DESIGN REVIEW APPLICATION | DESIGN ADJUSTMENTS

SGA PROJECT NO. 20-119

Design Review Application **DR-23-01**
Design Adjustments in Response to
Comments from June 13th HRB Meeting

DESIGN REVIEW APPLICATION | DESIGN ADJUSTMENTS – PART 2

01 WILLAMETTE FALLS DRIVE - ROOFSCAPE

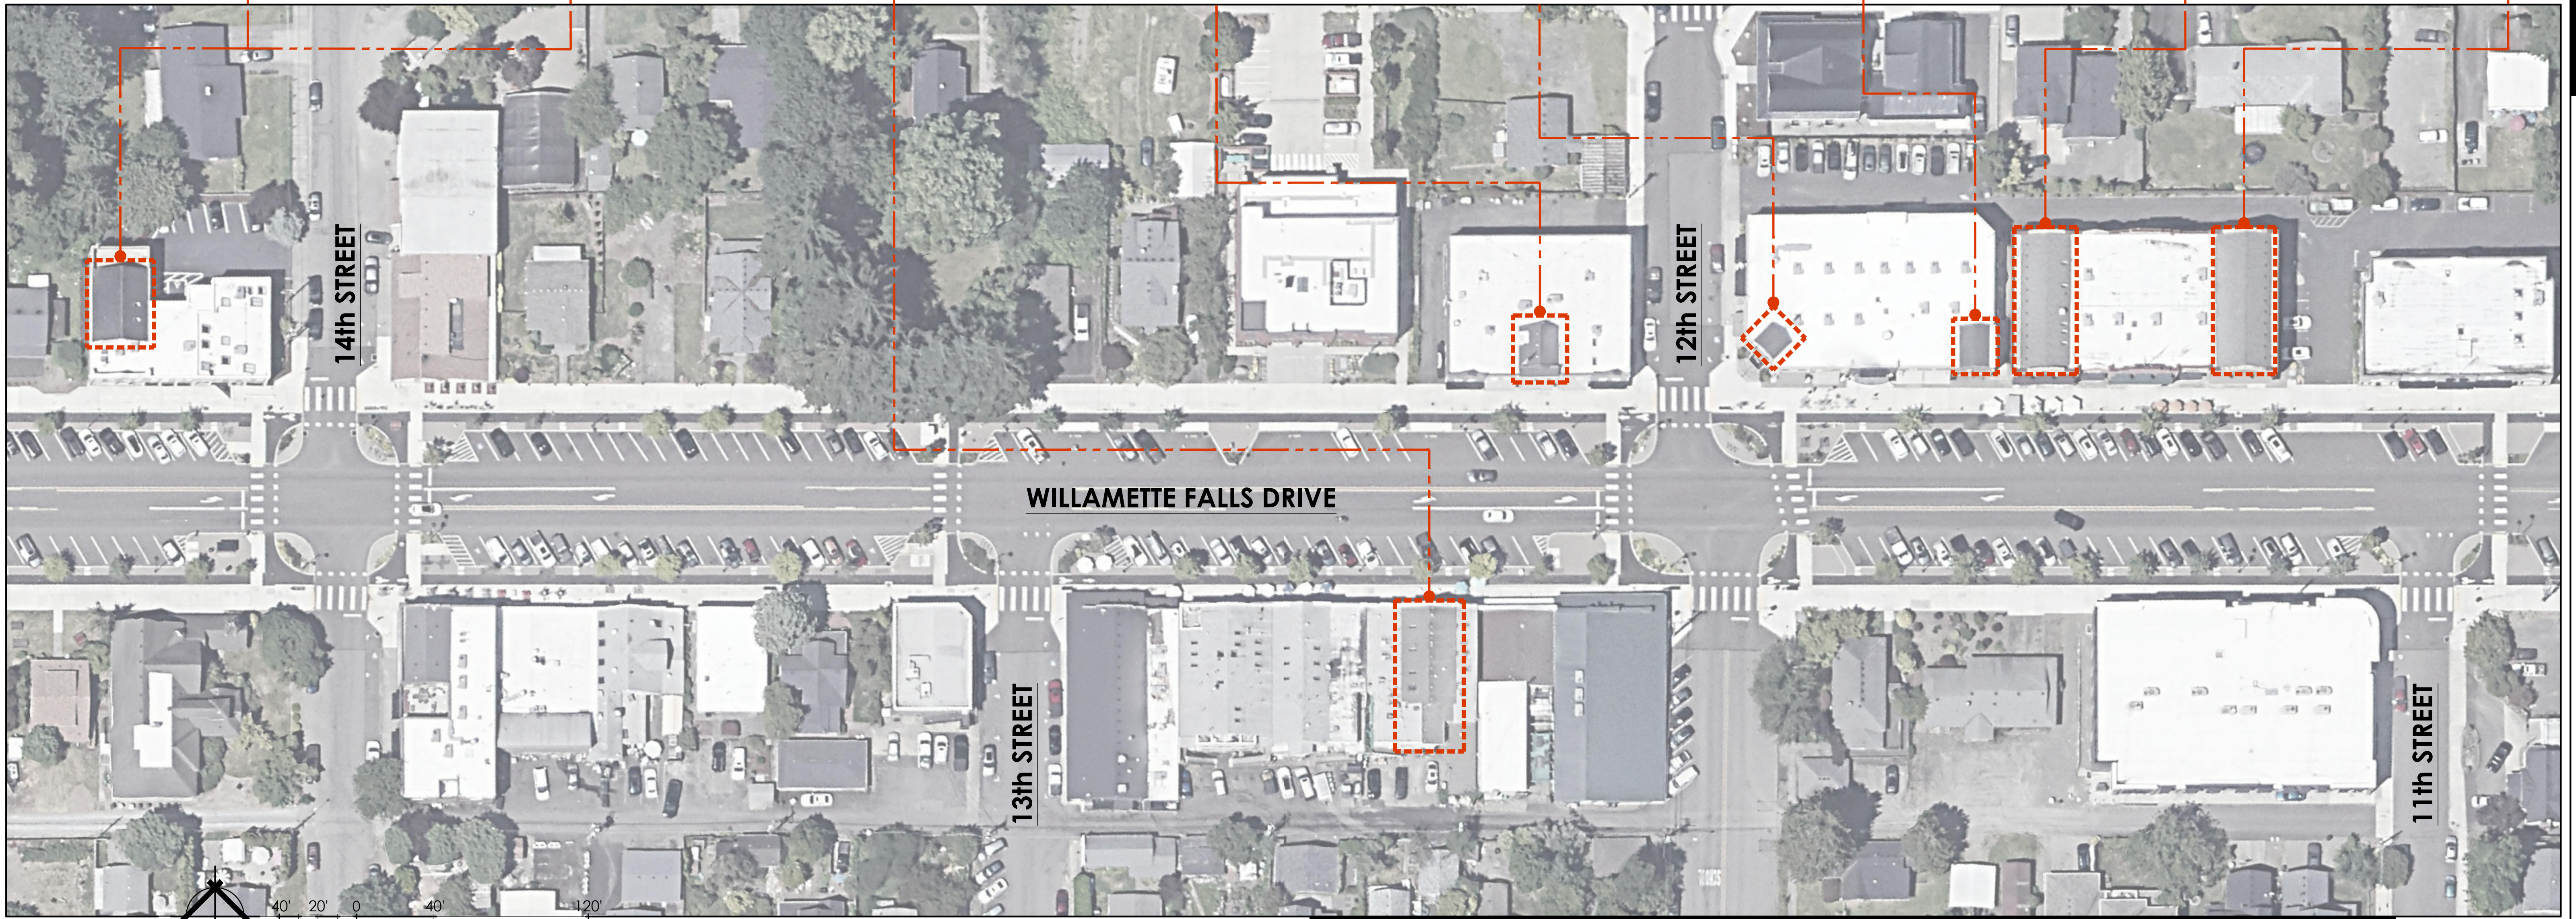
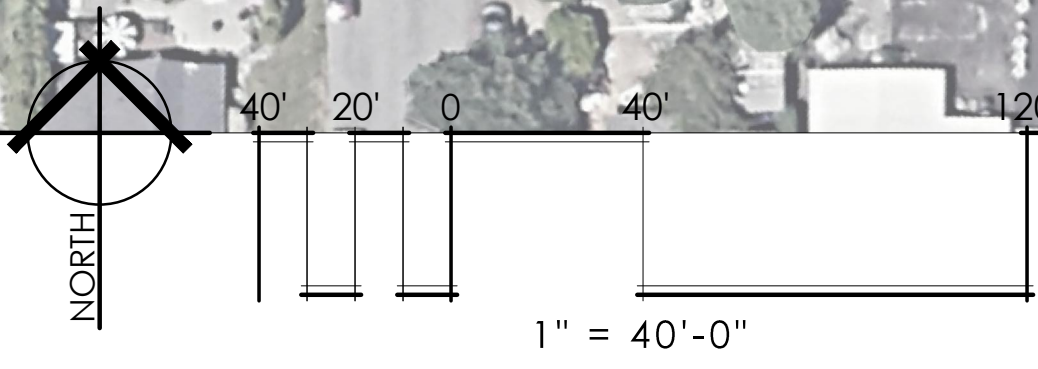
PART 2: In the previous submittal, the windows along 12th were removed and the cornice line adjusted, and the enclosed roof top spaces were revised to be un-conditioned and unoccupied storage and mechanical spaces. Nonetheless, Staff remains concerned that those enclosed spaces still constitute a third floor.

The proposed roof top spaces are not visible to the public, making the Chapter 58 criteria of period design and materials difficult to apply or evaluate. However, we feel that the existence of several buildings in the area with similar roof top spaces, including 1672, 1880, 1849, 1914, & 1980 Willamette Falls Drive should qualify the 1949 proposal for an exception to the 2-story standard.

The five buildings above each have covered roof top spaces for roof access and storage as is proposed for the 1949 project. As with the proposed project, the existing examples of covered spaces are hidden from view behind their western false front facades.
